Westinghouse Electric Company
Nuclear Power Plants
P.O. Box 355
Pittsburgh, Pennsylvania 15230-0355
USA

Subject: AP1000 Response to Request for Additional Information (SRP 3)

RAI-SRP3.8.4-SEB1-03 R3

RAI Response Number: RAI-SRP3.8.4-SEB1-03
Revision: 3

Figure 3H.5-10

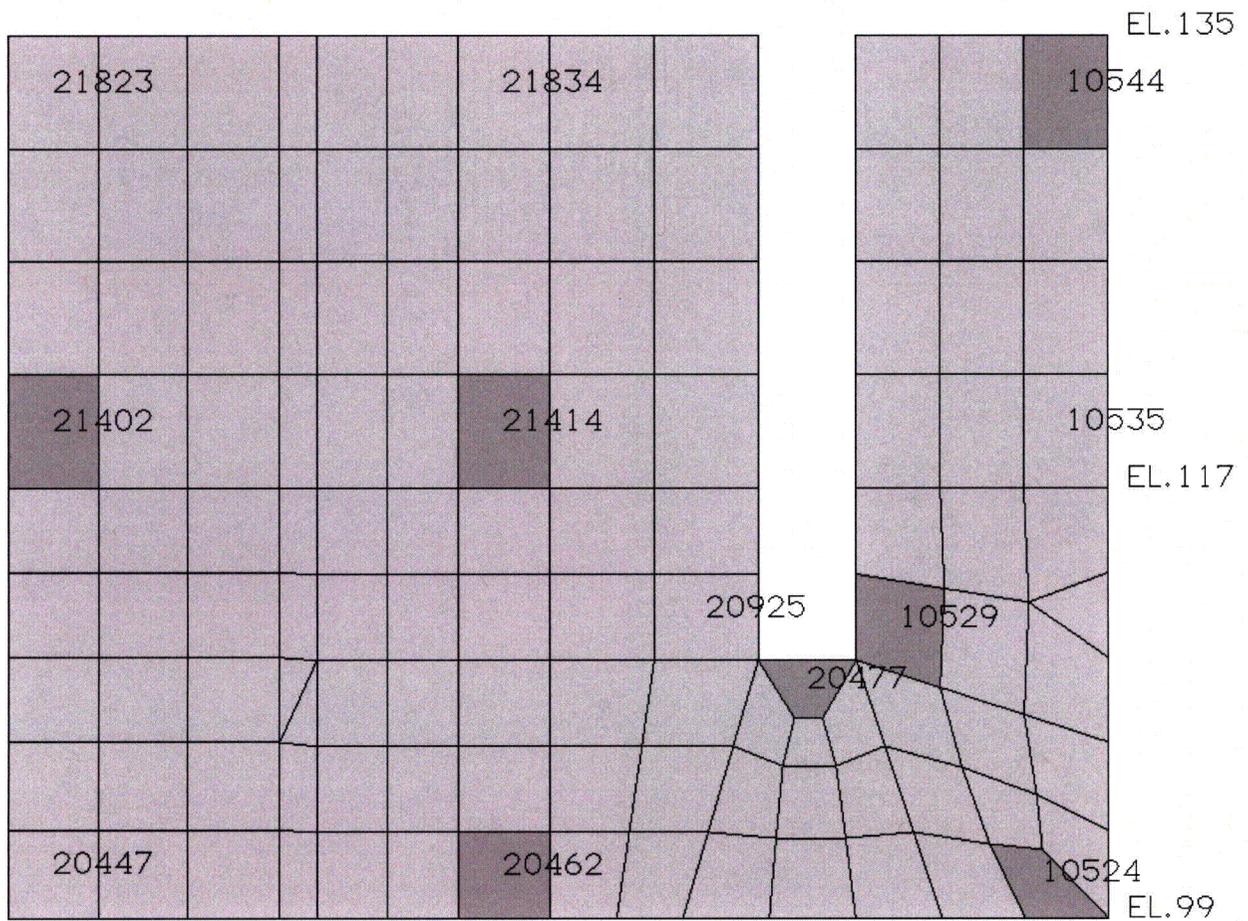
- a) DCD Section 3H.5 should discuss and refer to all of the tables that were added to the DCD;
- b) in Table 3H.5-8, include the same number and similar locations of critical sections that were provided in DCD Rev. 15;

2b. The same number of critical sections are provided in DCD Rev 18 as are provided in DCD Rev. 15. Each critical section has its own table. In DCD Revision 15 Table 3H.5-8 included information on five elements. The previous response provided informatin on three elements. Four additional sheets of Table 3H.5-8 will be added to the DCD for a total of seven elements to provide a design summary of spent fuel pool wall design loads, load combinations and

comparisons to acceptance criteria for other elements such as element no. 21402. A revised Figure 3H.5-10 is also provided showing the location of the elements.
